Project	<b>IEEE 802.16 Broadband Wireless Access Working Group</b> < <a href="http://ieee802.org/16">http://ieee802.org/16</a> >	
Title	Changes to Working Draft Document for conformance of Same PHY Profile Processes and the CX_CC concept	
Date Submitted	<b>2006-09-22</b>	
Source(s)	John Sydor, Shanzeng Guo Communication Research Center 3701 Carling Ave Ottawa, ON, Canada, K8H 8S2	Voice: (613) 998-2388 Fax: (613) 998-4077 { <a href="mailto:jsydor@crc.ca">jsydor</a> , <a href="mailto:sguo@crc.ca">sguo</a> }@ <a href="mailto:crc.ca">crc.ca</a>
Re:	IEEE 802.16h-06/015r1 – working group review.	
Abstract	This document Changes to Working Draft Document for conformance of Same PHY Profile Processes and the CX_CC concept.	
Purpose	This document updates the Working Draft Document for conformance of Same PHY Profile Processes and the CX_CC concept.	
Notice	This document has been prepared to assist IEEE 802.16. It is offered as a basis for discussion and is not binding on the contributing individual(s) or organization(s). The material in this document is subject to change in form and content after further study. The contributor(s) reserve(s) the right to add, amend or withdraw material contai

Figure h32 CCD Process

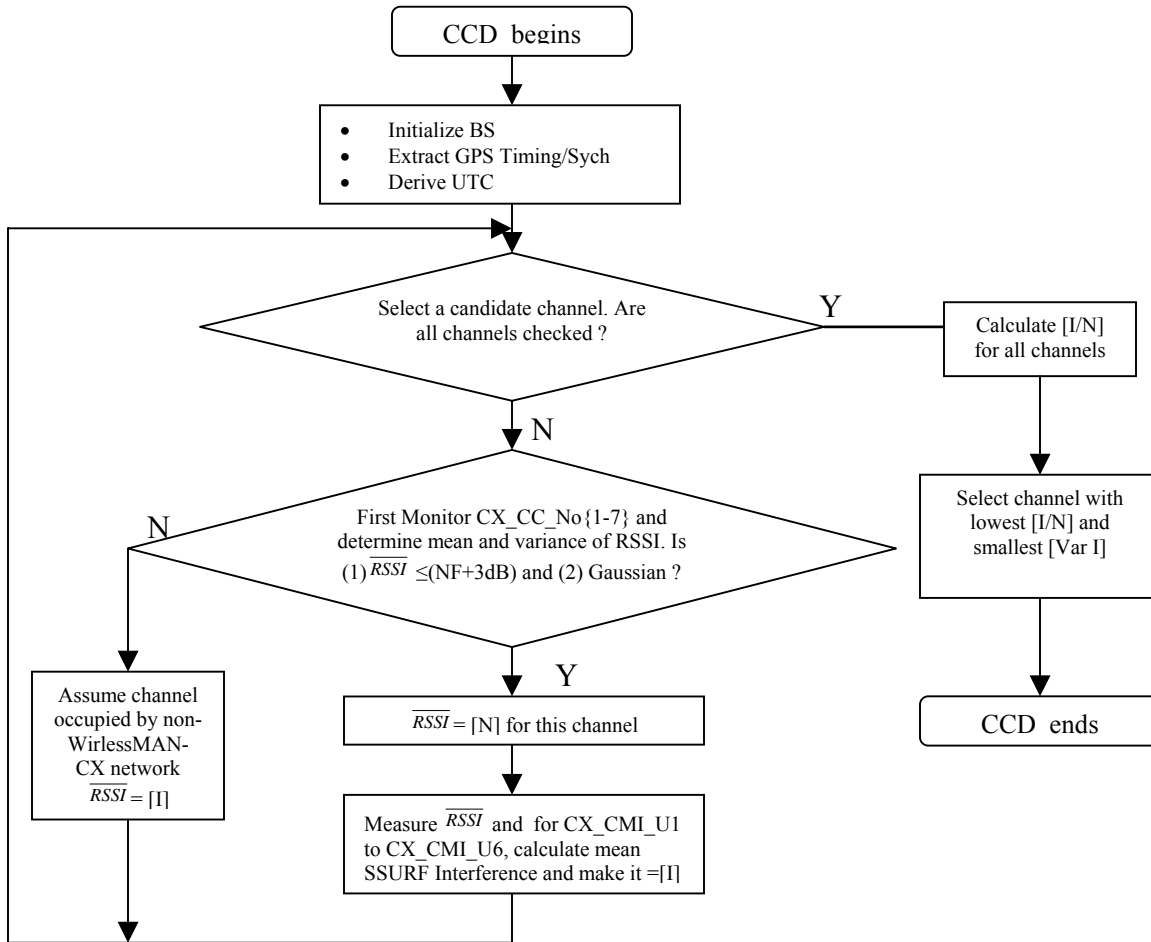
### **15.3.2.2 Candidate Channel Determination (Using GPS/UTC Synchronized CMI and Common Profile)**

Candidate Channel Determination (CCD) is the process used by WirelessMAN-CX systems (conforming to a synchronized CMI and common profile) where the base station monitors a band to which it has access and selects, within that band, a channel having minimal use and occupancy by neighboring wireless systems. This process is used, for example, by an IBS prior to undertaking entry into a Coexistence Community. Since a base station can only receive uplink traffic, this process relies on the monitoring uplink transmission intervals and the measurement of interference signal power [I] and noise power [N]. Each candidate channel will be ranked in terms of its (I/N) ratio. Those channels with the lowest ratio or ideally a ratio of 1 will be selected for use by the base station and be candidates for entry by an IBS, since such channels will have the lowest amount of discernable activity on them, hence likely have lower interference.

[I] and [N] will be determined using the RSSI measurement capability of the base station receiver as detailed in Section 8.4.11.2. After synchronization to the GPS and initialization of the base station operating parameters, the base station will select a channel and undertake noise floor measurements on  $CX\_CC\_No\{1-7\}$ , which are unoccupied  $CX\_CC$  slots (Section 10.5.2.3) used by WirelessMAN-CX networks, but may be used by non-WirelessMAN-CX networks (15.3.1.1.3.1)...or indeed any system synchronized to a GPS.

CX\_CC\_No{1-7}, in situations when it is unoccupied by any other wireless system, will be de-facto free from all WirelessMAN-CX transmissions and will provide an interval allowing the measurement of the receiver thermal noise floor [N]. The thermal noise floor is the noise power spectral density of the received channel ( $N_0$ ) multiplied by the channel bandwidth. Measurements will be undertaken long enough to determine whether [N] has Gaussian characteristics. Measurements not deemed as Gaussian and/or RSSI measurements that are 3 db (TBD) higher than a predetermined [N] value (which can be provided a-priori as a Receiver Noise Figure estimate within RSSI measurement algorithm in the base station receiver) will be an indication that channel may be occupied by non-WirelessMAN-CX users. In this instance the value of the mean RSSI will be taken as the [I] created by the occupying WirelessMAN-CX network and the given channel will be discarded from further consideration as it is considered occupied. Otherwise, the measurement will provide a value for [N].

[I] measurements will be undertaken by calculating the mean signal strength and variance due to uplink SSURF messages summed over intervals CX\_CMI\_U{1-6}. The number of CMI cycles to be measured will be a variable (TBD) set for the base station by the operator. Measurement of the RSSI will be done in accordance with Section 8.4.11.2, with care being taken to ensure that valid signals are being measured, even at close-to noise floor levels. The mean RSSI and variance calculated for the summed CMI intervals of the channel will be construed as interference values [I] and [Var I] for the channel. In essence, what this measurement represents is the total power that the Base Station measures, on a given channel, due to the total of all Subscriber Stations operating on that channel. *{Because of the granularity of the measurements ( each interfering SS will be separately detected) it will be possible for the BS to obtain a more sophisticated understanding of the interference environment above and beyond what is simply given by [I] and [Var I]. The incorporation of such more advanced interference detection approaches will not be presently considered in the context of the current discussion however}*.

The channels are then ranked, with the channel having the lowest I/N and smallest [Var I] measurements likely selected for IBS entry into a Coexistence Community. This process is undertaken for each channel that is specified forms the band of operation for the WirelessMAN-CX system and in essence identifies “white space” spectrum. Additionally, the passive PSD monitoring process described in Section XXX can be considered as a parallel process to the CCD, and can be used as another method of ascertaining spectrum occupancy. Figure h32 shows the CCD process.

Figure h33. IBS community entry process for Same PHY Systems using CX\_CC CMI signaling .

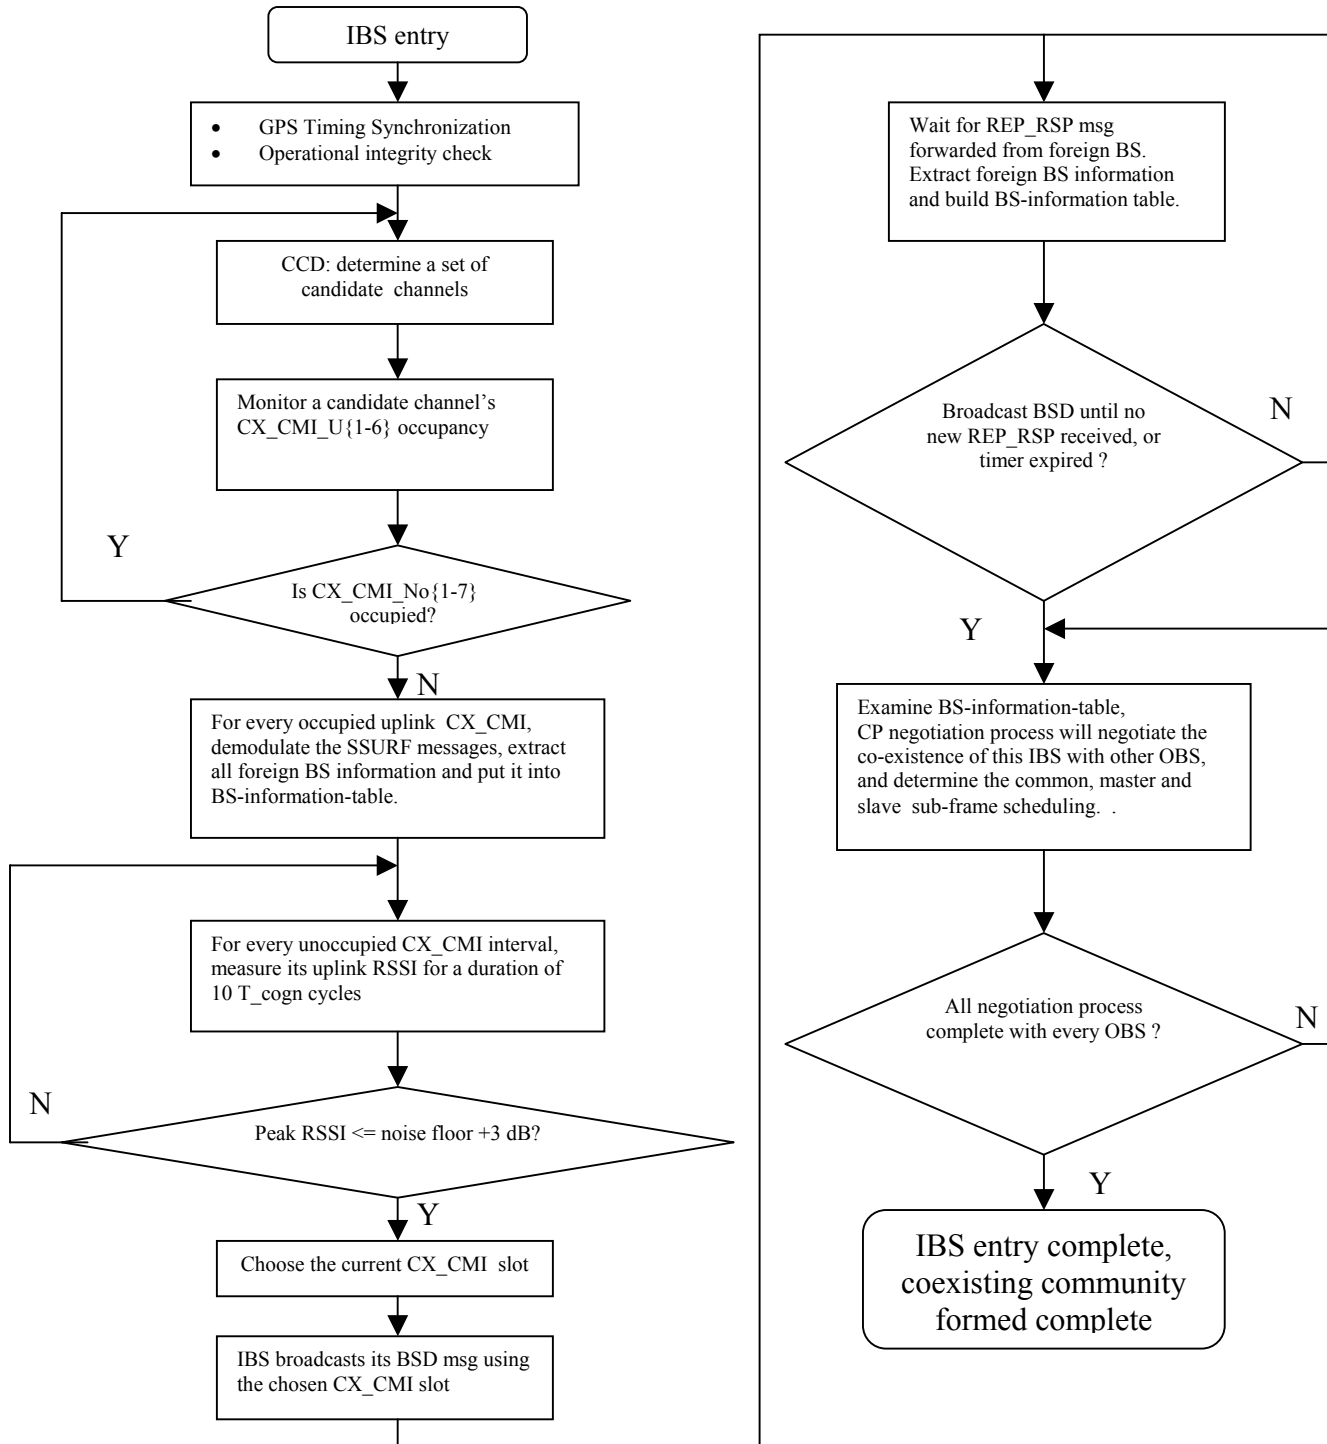
### **15.3.2.3 Entry of a new BS into a Interference Neighborhood and the Creation of a Coexistence Community Using CX\_CC Synchronized Systems having the Same PHY profile**

In applications where the CX\_CMI intervals are synchronized to the CX\_CC and are used with systems having a common (same) PHY profile, entry of a new Base Station (IBS) will be undertaken in 4 steps, with the IBS:

- (a) Monitoring the CX\_CMI uplink Intervals,
- (b) Selecting an Empty CX\_CMI downlink interval,
- (c) Claiming an empty CX\_CMI downlink interval,
- (d) Becoming a member of a Coexistence Community using the claimed CX\_CMI.

Prior to entry into a Community of Operating Base Stations (OBS) it is assumed that the IBS will have undertaken the Candidate Channel Determination (Section 15.3.2.2) process and has selected a candidate channel and has no operational SS yet deployed. It is assumed that the IBS is deployed within an Interference Neighborhood, ie: active interference from existing operating systems is present. The IBS entry process is shown in Figure h33. Figure h34 shows aspects of the entry procedure with signaling.
